TYPICAL SECTION

PROPOSED . . PVCu GEORGIAN PORCH
AT . . . . . 43, Hyde End Lane,
Ryeish Green,
READING.
RG7 1EP.
FOR . . . . Mr. & Mrs. Wallace

DRAWING No. 099/01917a	DRAWN BY.. SIMON DRAKE	DATE 02/06/00
BRANCH NAME	SURVEYOR.. R.Hill	DATE 7/6/00

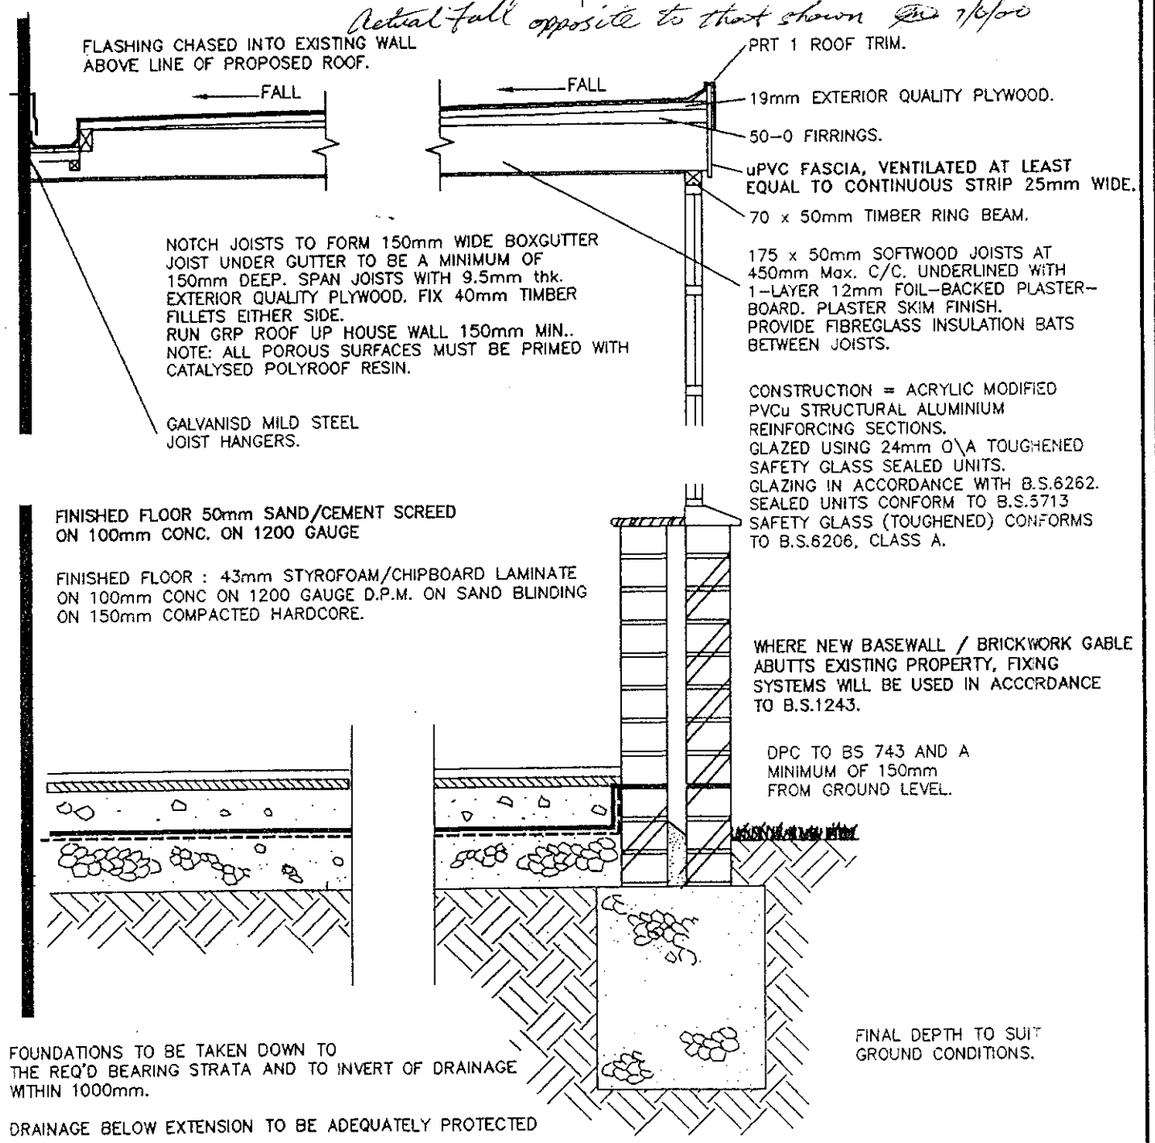
actual fall opposite to that shown 7/6/00

SURVEYORS BASE PLAN

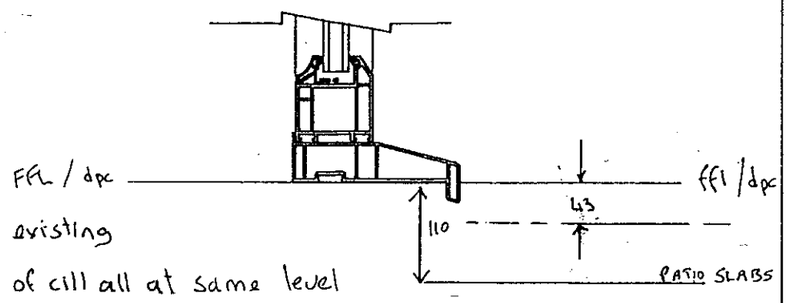
4. ANY EXISTING BRICK VENTS TO BE DUCTED THROUGH PROPOSED BASE.
5. GROUND LEVEL TO BE LOWERED LOCALLY TO GIVE REQUIRED CLEARANCE FOR D.P.C.
6. SURFACE WATER TO BE DISCHARGED VIA NEW 68 DIA. RAINWATER DOWN PIPE AND SHOED INTO ~~GRATING OVER GULLEY AND INTO 100 DIA. UPVC DRAIN BEDDING ON PEA SHINGLE TO FALL 1:40 min INTO NEW SOAKAWAY 5.0 m. MIN. AWAY FROM BUILDINGS, TO BE FILLED WITH HARDCORE, AGGREGATE AND PEA GRAVEL~~ EXISTING

7. ~~BUILD NEW mm (COURSE) BASE WALL ABOVE D.P.C LEVEL OF UNIT.~~
   ~~BASE WALL TO BE CONSTRUCTED IN 100 MM THICK BLOCKWORK/BRICKWORK INTERNALLY, 50 MM THICK CAVITY FILLED WITH FIBREGLASS INSULATION BATS,~~
   100 MM THICK BRICKWORK EXTERNALLY, AND TO INCORPORATE D.P.C MIN 150 MM ABOVE GROUND LEVEL AND TO INCLUDE "BUTTERFLY" GALVANISED WIRE TYPE WALL TIES STAGGERED 900 MMM HORIZONTALLY, 450 MM VERTICALLY AND TO BE DOUBLED UP AROUND CORNERS AND REVEALS.
   CLOSE INTERNAL SKIN AT JAMBS AGAINST 150 MM WIDE D.P.C
   CAVITY BELOW GROUND LEVEL TO BE FILLED WITH LEAN MIX CONCRETE TO WITHIN 150 MM OF D.P.C. LEVEL OF UNIT.
   ALL NEW VISIBLE BRICKWORK, INCLUDING BRICKWORK BELOW D.P.C. LEVEL AND ABOVE EXTERNAL GROUND LEVEL TO PERIMETER OF UNIT TO MATCH EXISTING HOUSE BRICKWORK (WHERE POSSIBLE).

8. KNOCK THROUGH – FINISH REVEALS WITH STUD + PLASTERBOARD
9. FALL ON POLYROOF FROM BACK TO FRONT

- FFL + dpc to match existing
- FFL / dpc / underside of cill all at same level

Customers Signature	Date	Drawing No.	Property Elevation:	Unit Elevation:	Scale..	Drawn..
..W Wallace..	7/June/00	099/01917a	SIDE	SIDE ELEVATIONS.	1:50	SDR
					Date.. 02/06/00	Surveyor. R.Hill

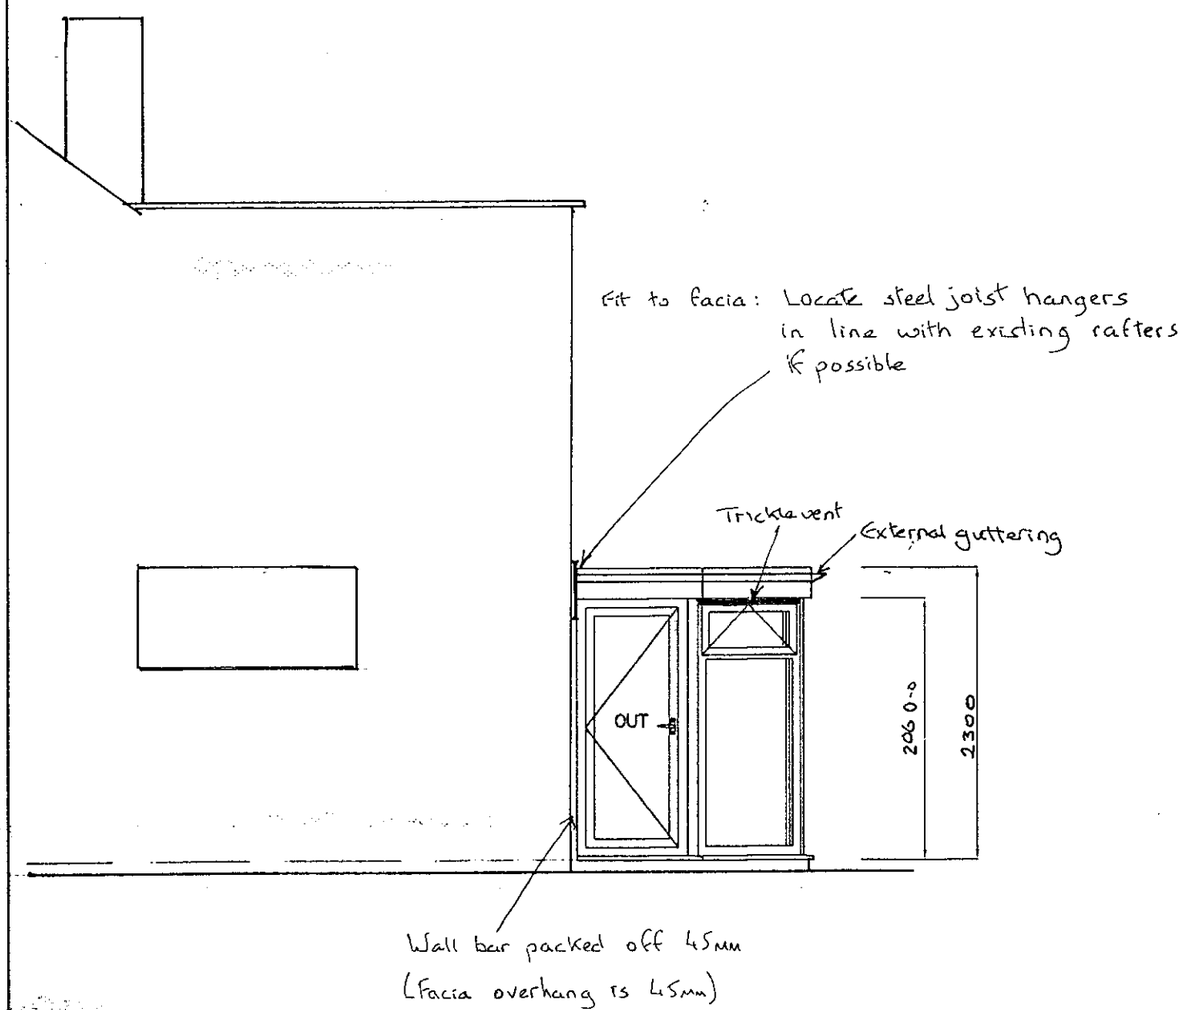
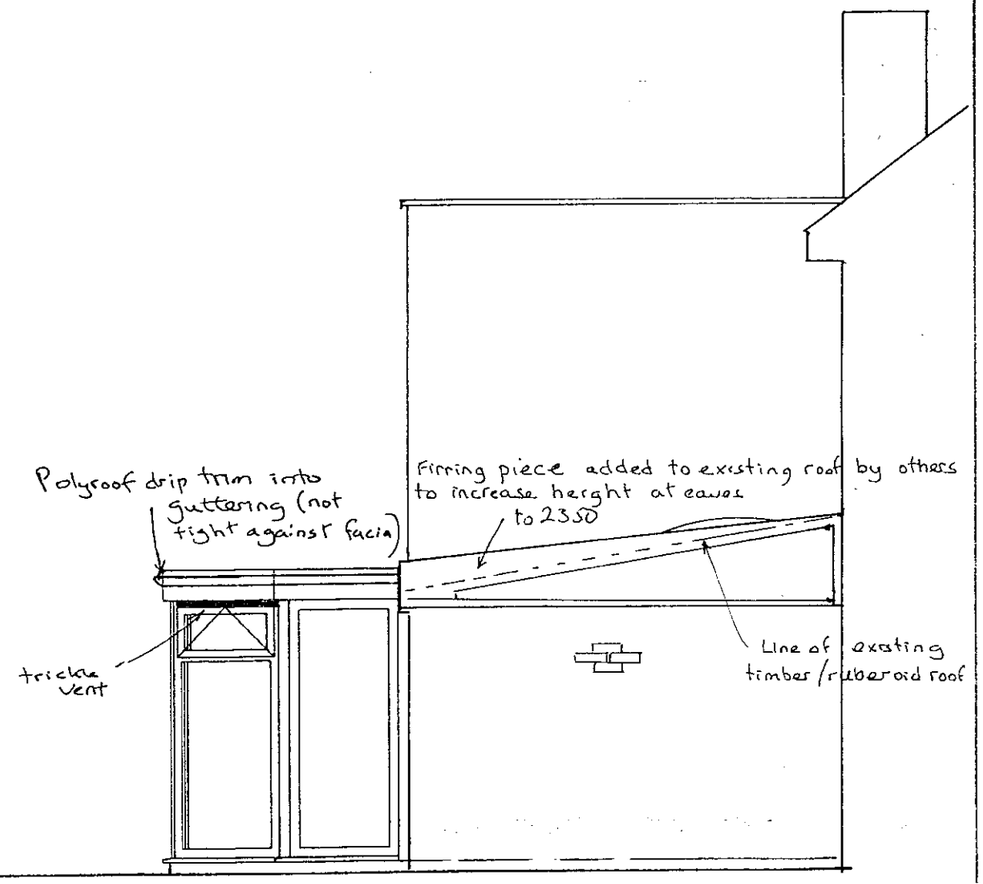
Fitters:
Fall on roof to run from back to front
Recommend 50—0 firring.
